ENGINE - HP COMPRESSOR - CONTROLLED SERVICE USE OF INSTRUMENTATION FOR HP COMPRESSOR,
HANDLING BLEED VALVES AND CABIN AIR PRESSURE MONITORING CHECKS - NOT APPLICABLE -
MOD.ENG-72-0210

(1) Aircraft: Airbus A320

(2) Engine: V2500-A1 Engines, IAE to advise engine serial number and aircraft. This Service Bulletin must be incorporated only on one engine per aircraft. Do this Service Bulletin before you do Service Bulletin V2500-ENG-72-0209.

Section AP Before and After Alteration
Fig.6

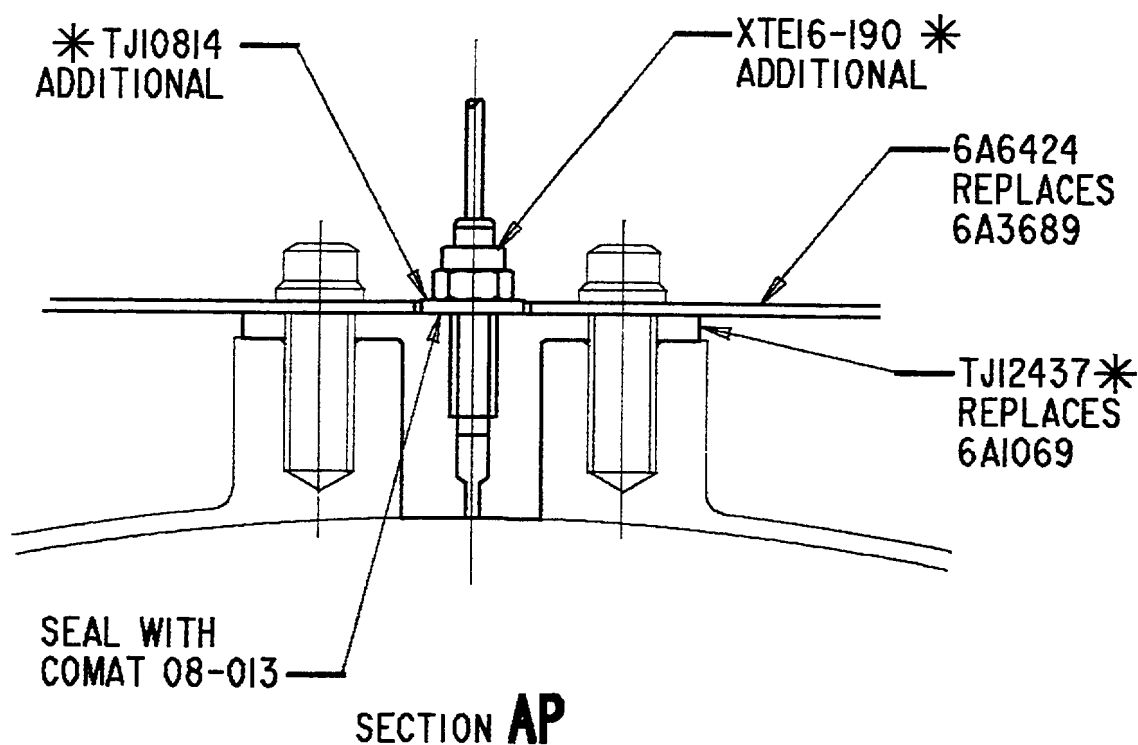
- (21) Install the Kulite matched assembly SD3HCT.C to the HP casing at arrow AF port using the AS21011 bolts (2 off) and 6A6424 bracket. Refer to Figures 3 and 6.

Section AR Before and After Alteration
Fig.7

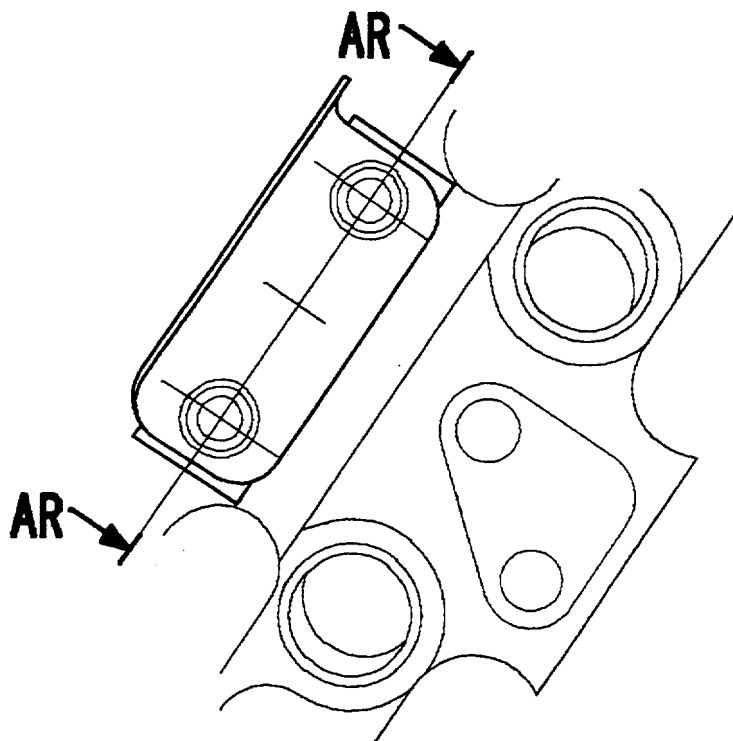
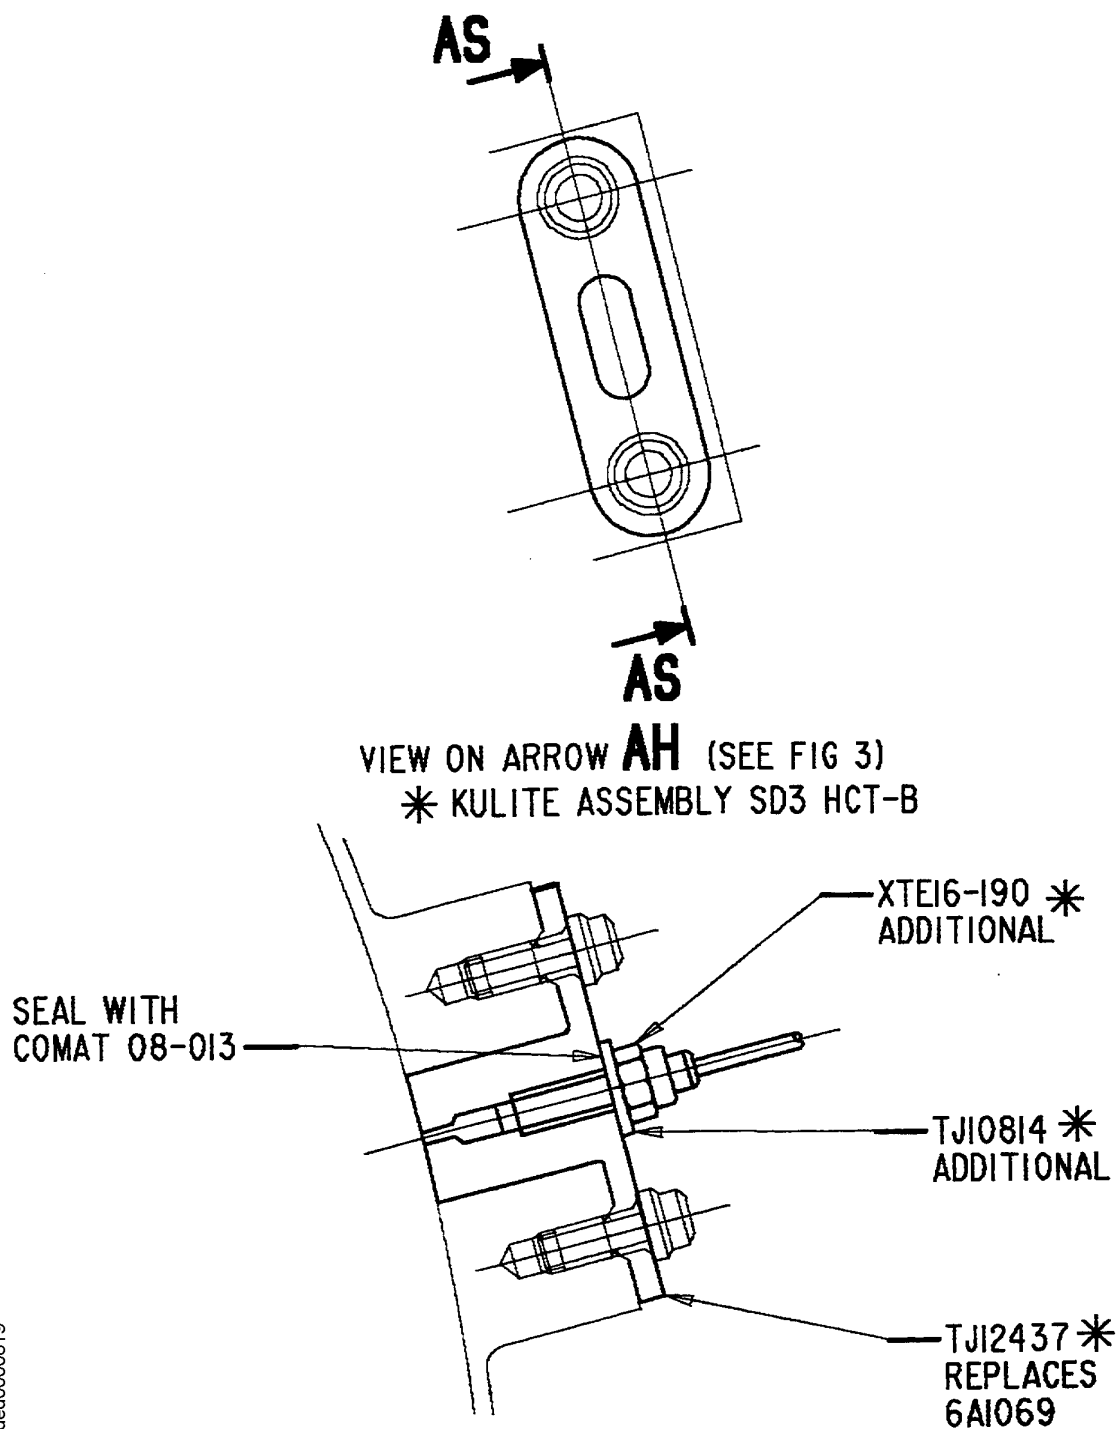
- (22) Install the Kulite matched assembly SD3HCT.A to the HP casing at arrow AG port using the AS21011 bolts (2 off) and 6A6425 bracket. Refer to Figures 3 and 7.

TJ12437 *
REPLACES
6A1069

6A6425
REPLACES
6A3080

XTE16-190 *
ADDITIONAL

TJ10814 *
ADDITIONAL

Section AS Before and After Alteration
Fig.8

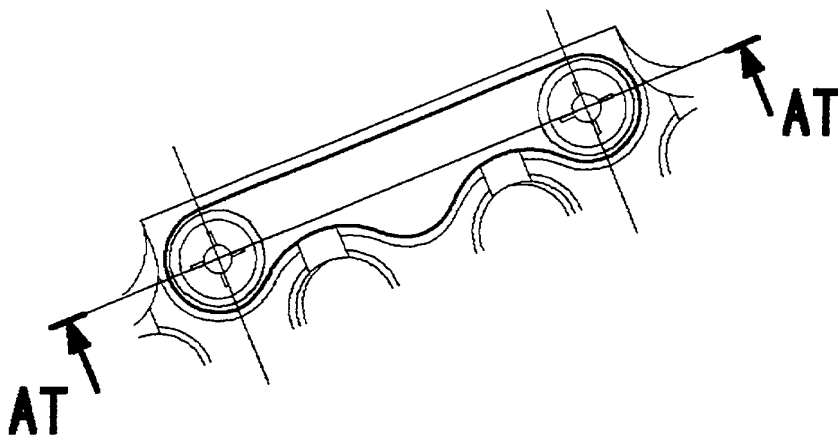
- (23) Install the Kulite matched assembly SD3HCT.B to the HP casing at arrow AH port using the AS21011 bolts (2 off). Refer to Figures 3 and 8.

Section AT Before and After Alteration
Fig.9

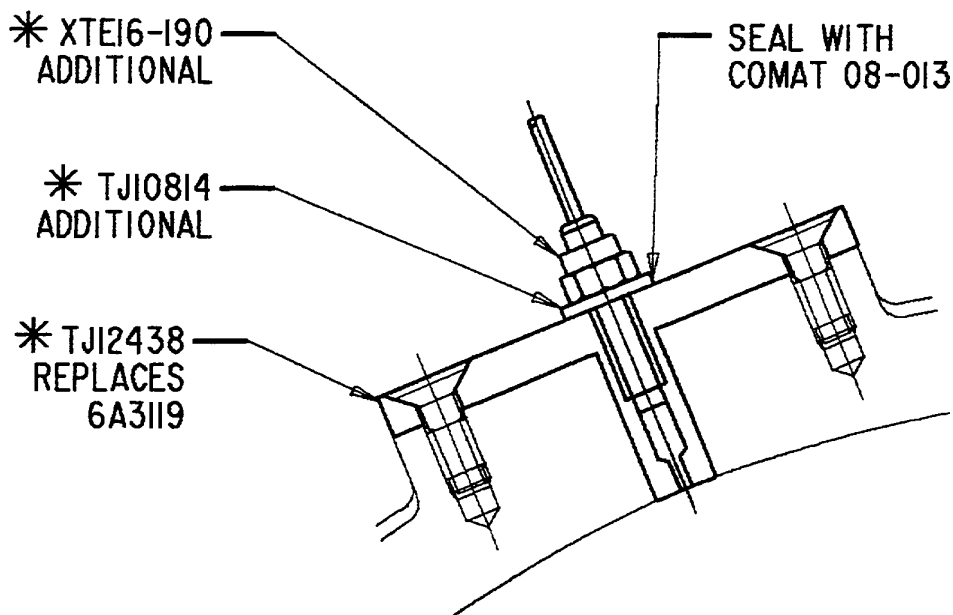
- (25) Install the Kulite matched assembly SD5 HCT.Y to the HP Compressor Stage 5 borescope access port cover (Port C) as instructed in the A320 Aircraft Maintenance Manual Task 72-00-00-200-010-A01. Refer to Figures 4 and 9.
WARNING WHEN YOU USE COMAT 01-001 INHIBITED AND STABILISED TRICHLOROETHANE YOU MUST USE THE NECESSARY PROTECTIVE CLOTHING. DO NOT GET THE SOLVENT ON YOUR SKIN OR IN YOUR EYES. YOU MUST NOT SMOKE WHEN YOU USE THE SOLVENT AS THE VAPOUR CHANGES AND BECOMES TOXIC.

View on Arrow AU Before and After Alteration
Fig.10

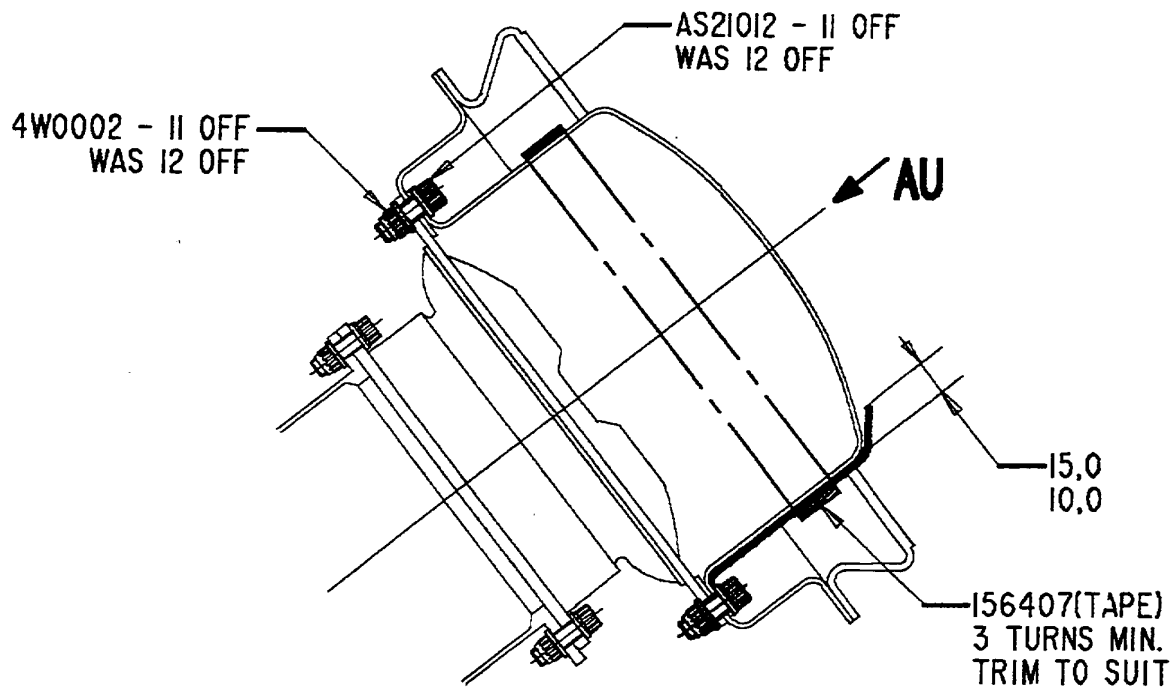
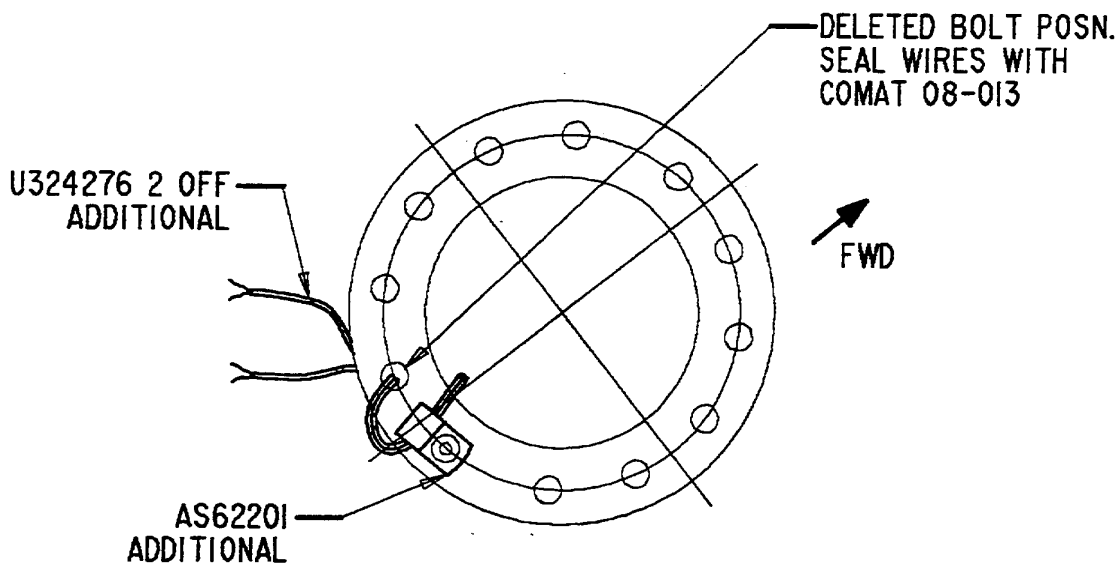
- (13) Stage 7 upper right hand bleed valve, remove 4W0002 nuts (2 off) and AS 21012 bolts (2 off), install 2 thermocouples thru one bolt hole location and secure at the other bolt hole location using AS 62201 clamp, AS21012 bolt and 4W0002 nut. Retain other AS21012 bolt and 4W0002 nut. Refer to Figures 1, 2, 5 and 10.

View on Arrow AV Before and After Alteration
Fig.11

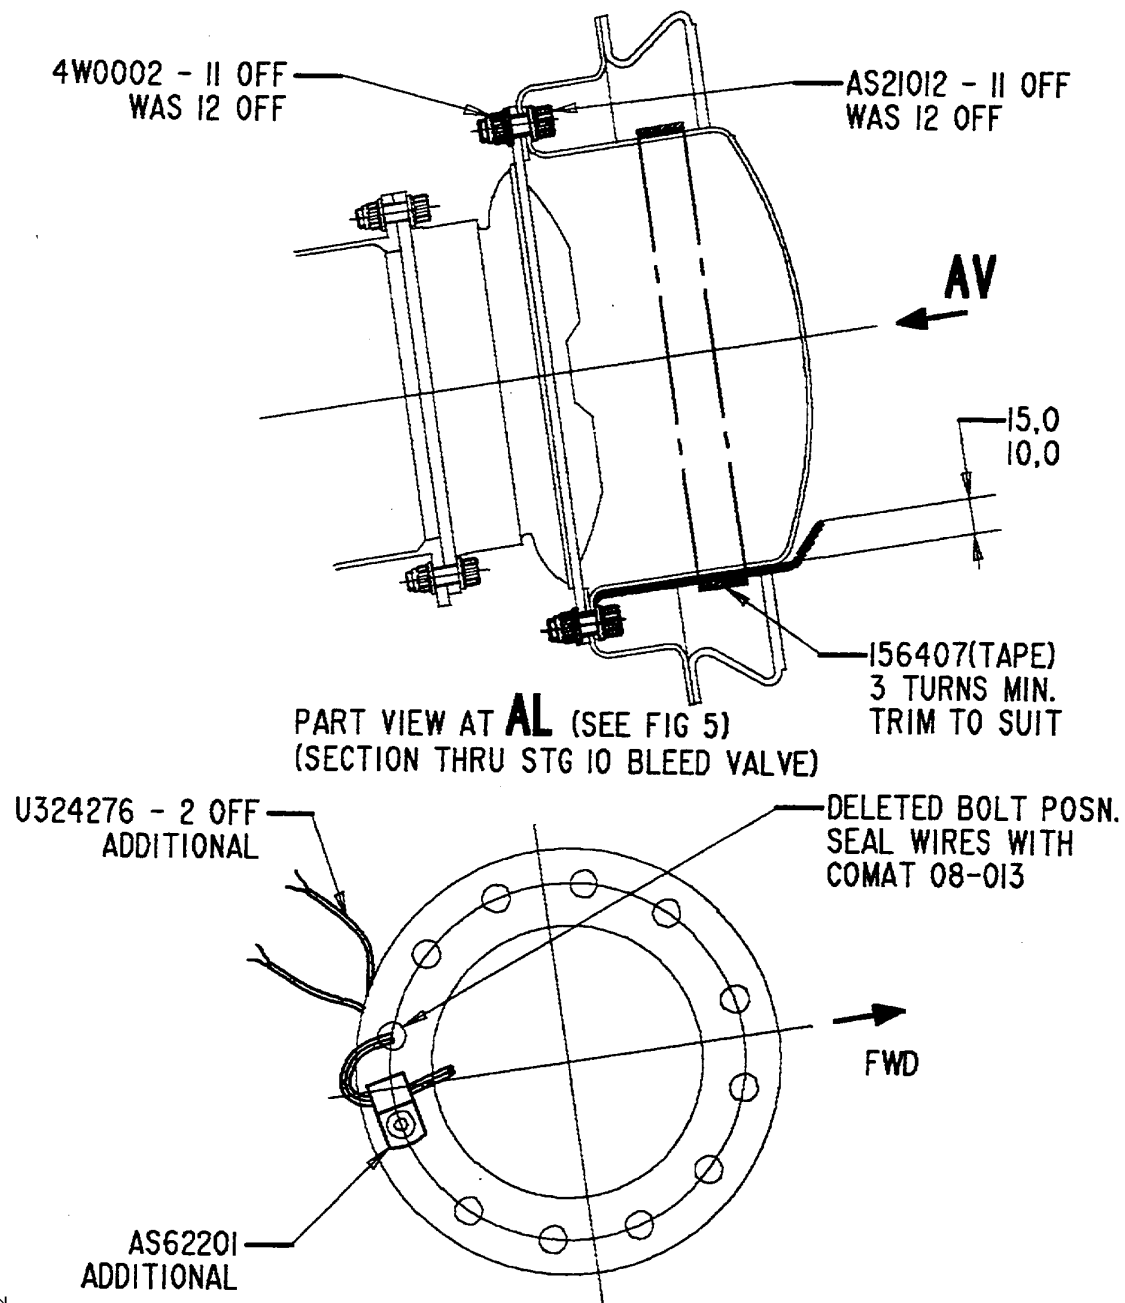
- (15) Stage 10 upper right hand bleed valve, remove 4W0002 nuts (2 off) and AS21012 bolts (2 off), install 2 thermocouples thru one bolt hole location and secure at the other bolt hole location using AS62201 clamp, AS21012 bolt and 4W0002 nut. Retain other AS 21012 bolt and 4W0002 nut. Refer to Figures 1, 2, 5 and 11.

View on Arrow AW Before and After Alteration
Fig.12

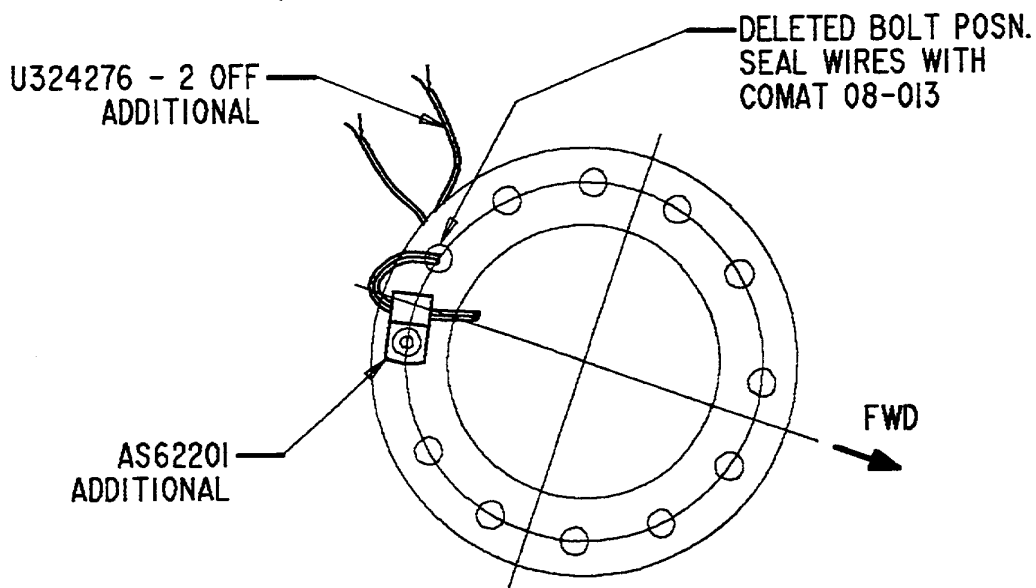
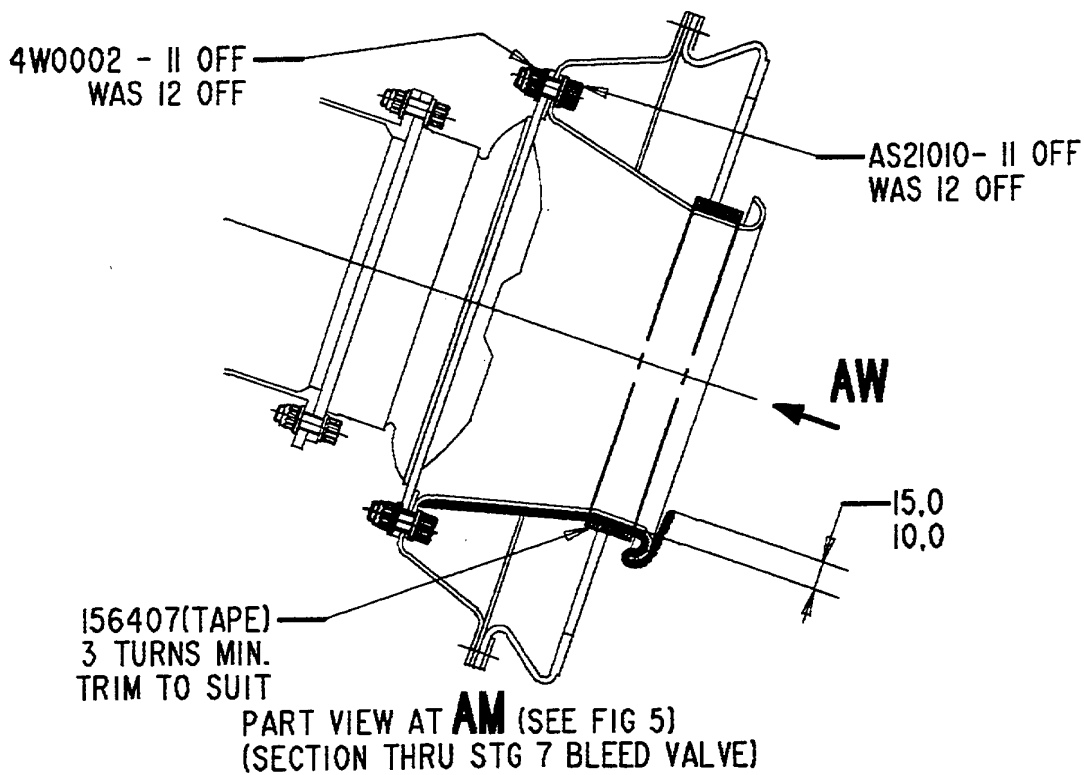
- (14) Stage 7 lower right hand bleed valve, remove 4W0002 nuts (2 off) and AS 21010 bolts (2 off), install 2 thermocouples thru one bolt hole location and secure at the other bolt hole location using AS 62201 clamp, AS21010 bolt and 4W0002 nut. Retain other AS21010 bolt and 4W0002 nut. Refer to Figures 1, 2, 5 and 12.

View on Arrow AX Before and After Alteration
Fig.13

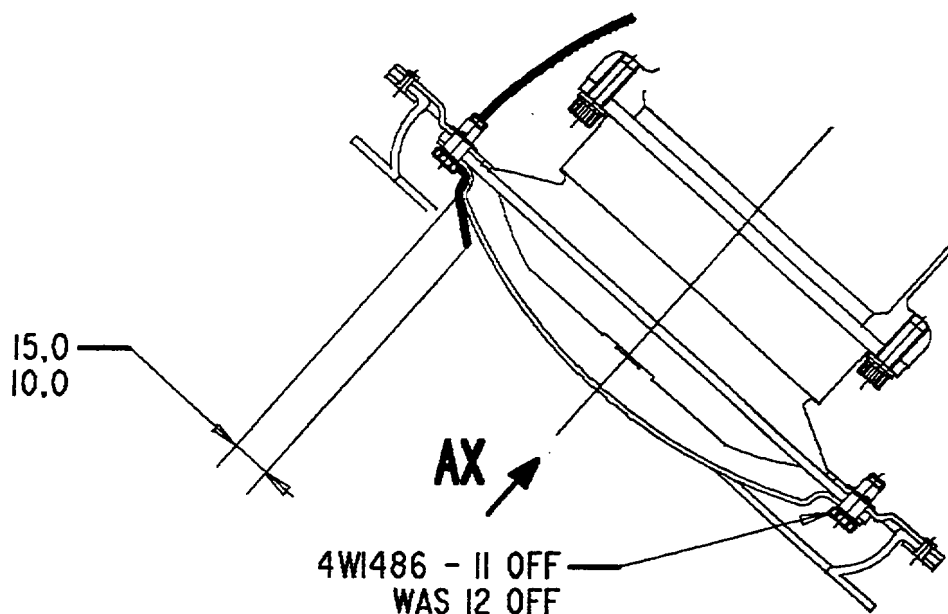
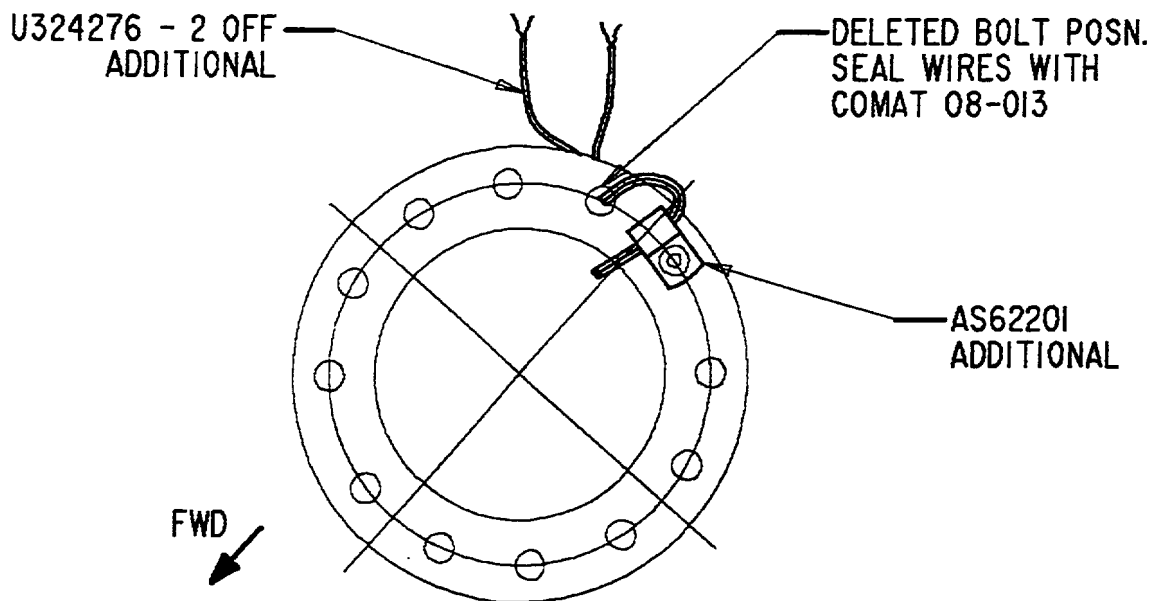
- (12) Stage 7 lower left hand bleed valve, remove 4W1486 bolts (2 off), install 2 thermocouples thru one bolt hole location and secure at the other bolt hole location using AS62201 clamp and 4W1486 bolt. Retain other 4W1486 bolt. Refer to Figures 1, 2, 5 and 13.
